Permit Number: 051347

has permission to Single Family 28 x 34 Cape full rear

AT 90 FARRAGUT ST L 339 J055001

CHECK-LIST AGAINST ZONING ORDINANCE # 05-1347

TITLE:  
 SITE PLAN -  
 LOT 2 FARRAGUT STREET

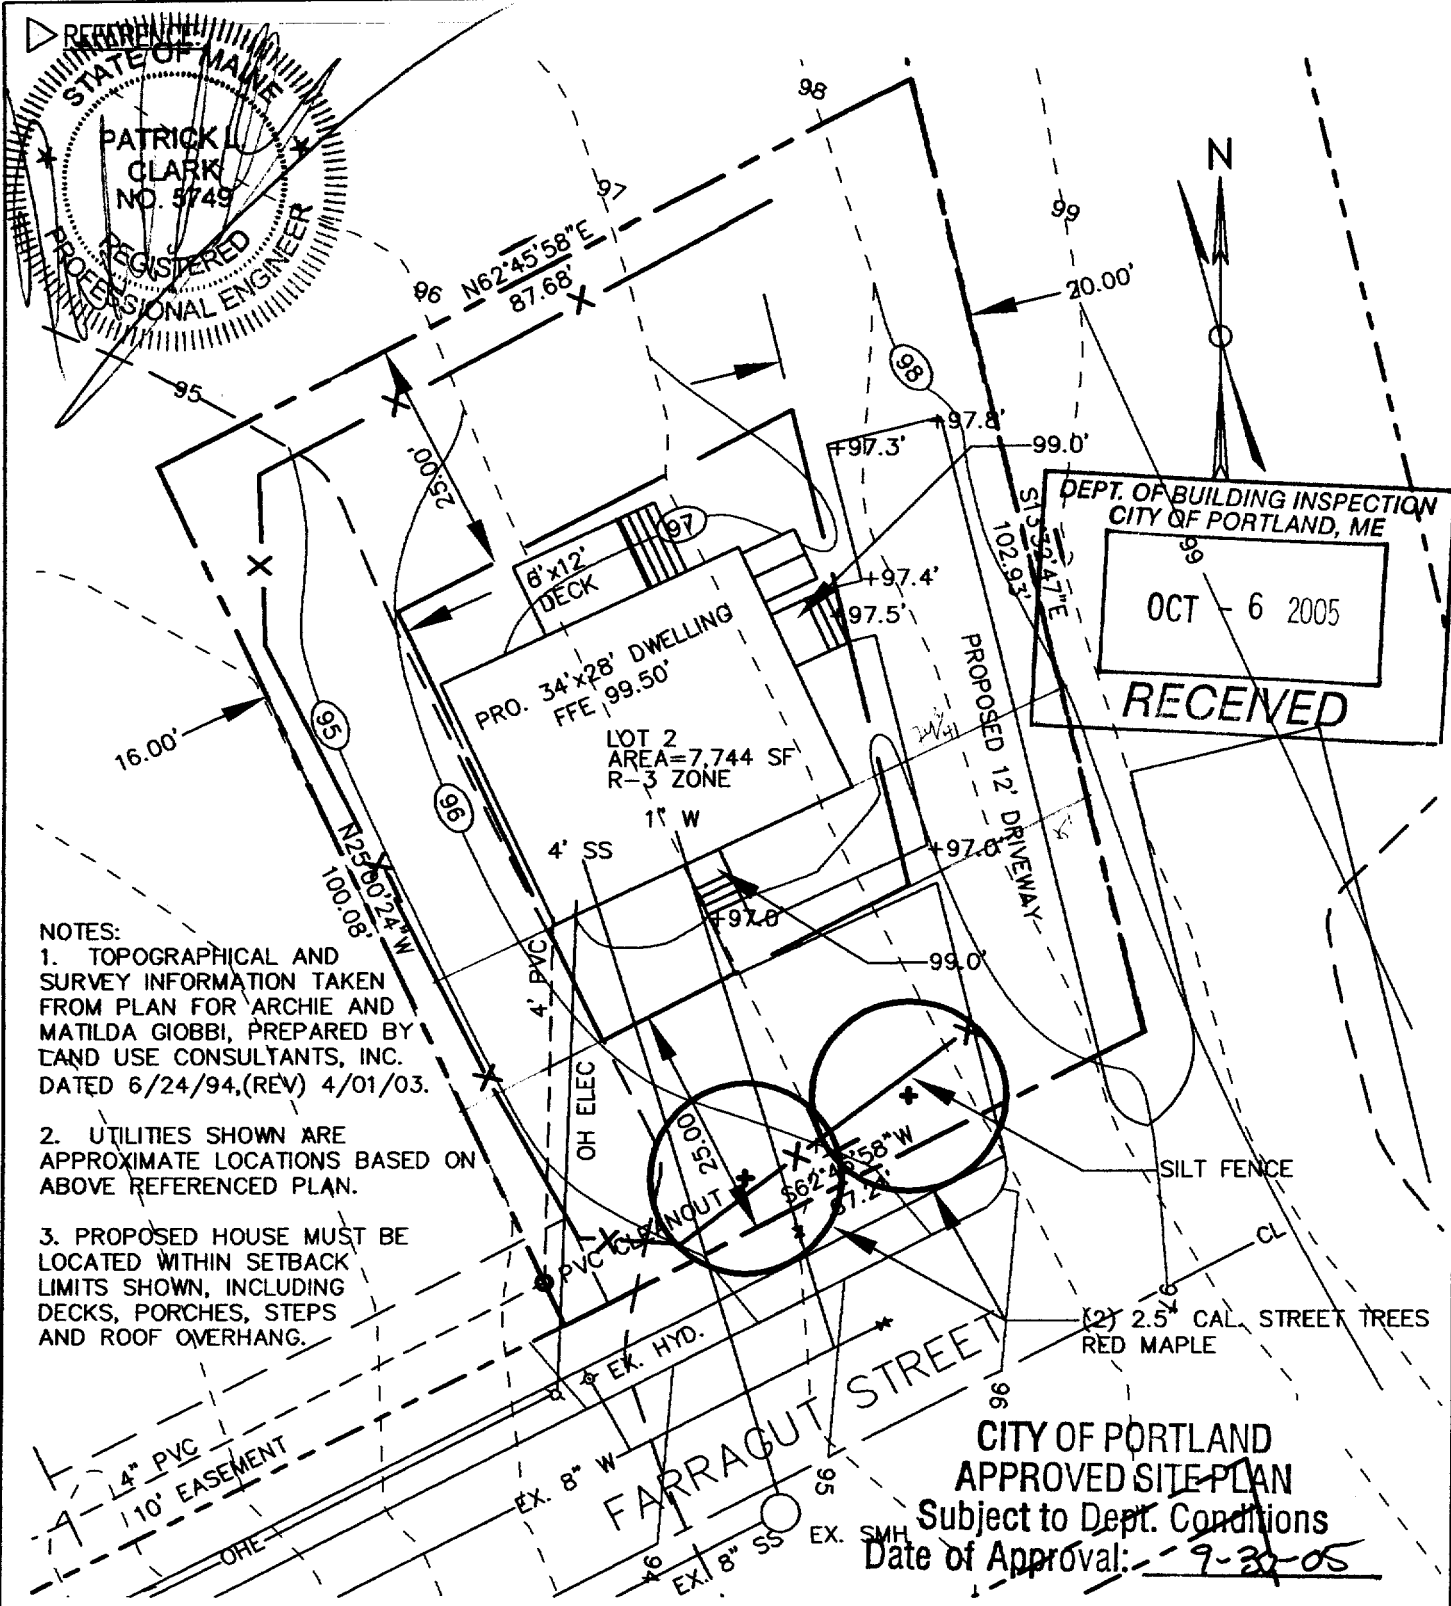
**Note:** 10/6/05 Left message with Kirsten. Need revised site plan showing 5' setback for driveway parking.      **Ok to Issue:**

OK → Off-street Parking - 2 pkg spaus req. - 2 shown beyond required setback  
- Violates Section 14-336a

10/6/05-GG: received revised site plan. /gg

1' not 5' OK see new plan 10/6
